PRATT & WHITNEY CANADA  
**SERVICE BULLETIN**

P&WC S.B. No. 41052R2

TURBOSHAFT ENGINE  
OIL TRAY, ACCESSORY GEARBOX - REPLACEMENT/MODIFICATION OF

PT6C-67C

Tray Assembly - Modification  
Figure 1

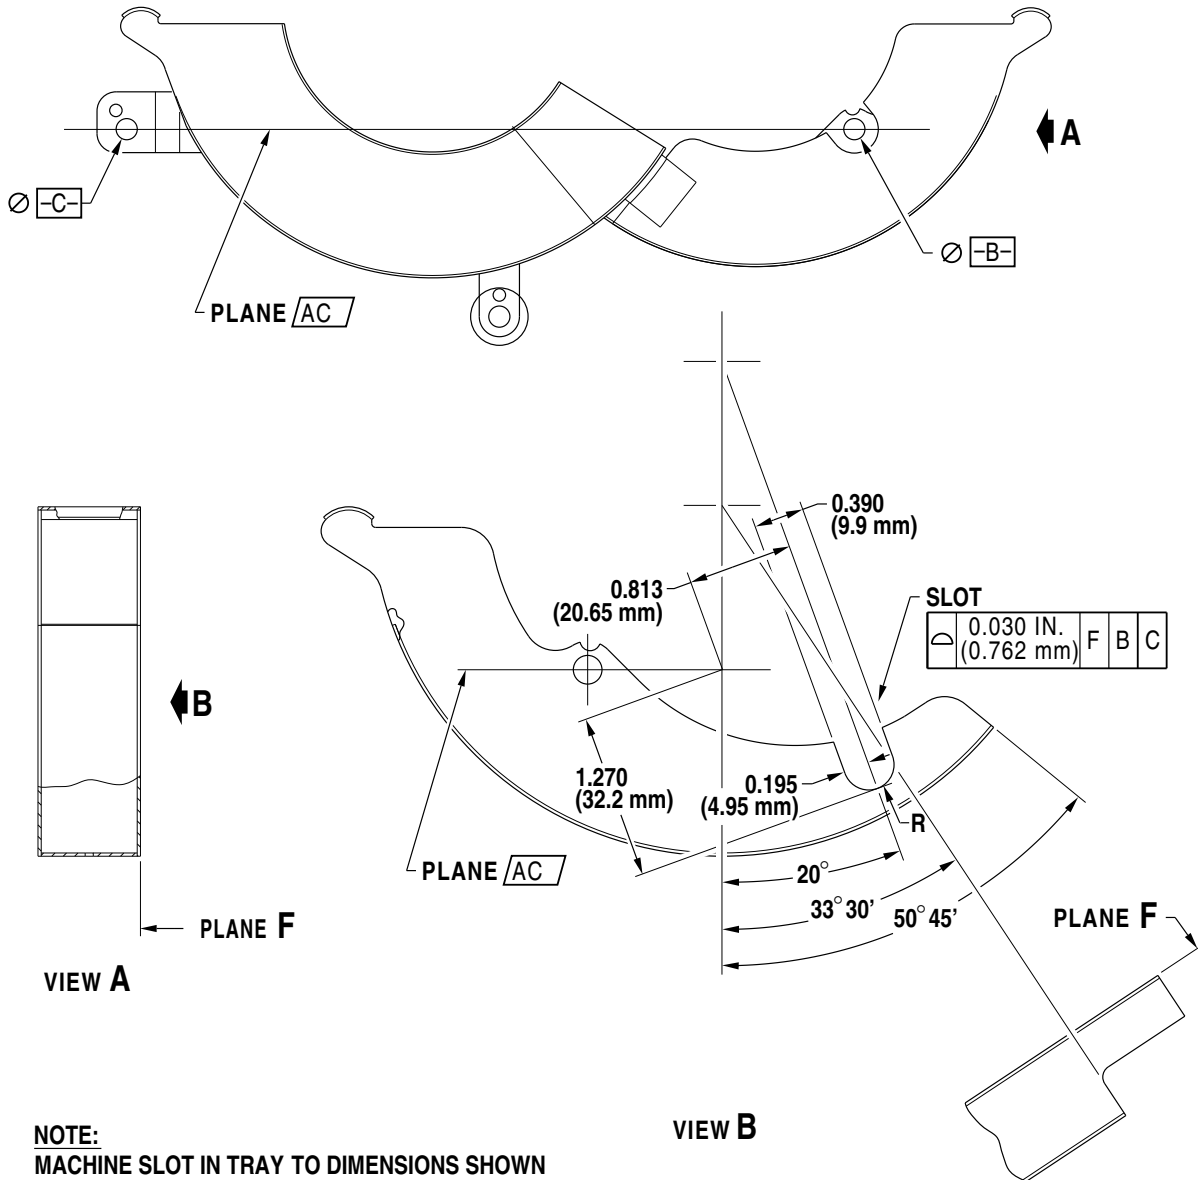
There can be interference at assembly between the accessory gearbox oil tray and the oil pump cover jacking insert.

The clearance between the oil tray and the oil pump cover jacking insert is not optimal.

Replace the accessory gearbox oil tray with a new one which has a cut-out to facilitate the installation.

- B. To modify the old tray assembly, do as follows:

- (1) Machine a slot in tray to dimensions shown (Ref. Fig. 1).
- (2) Break edges 0.003 to 0.015 inch (0.0762 to 0.3810 mm).

- (3) Use the electrolyte etch procedure, 0.002 in. (0.05 mm) deep maximum, and put a line across the old part number. Write the new part number 3076382-01 in the same area.
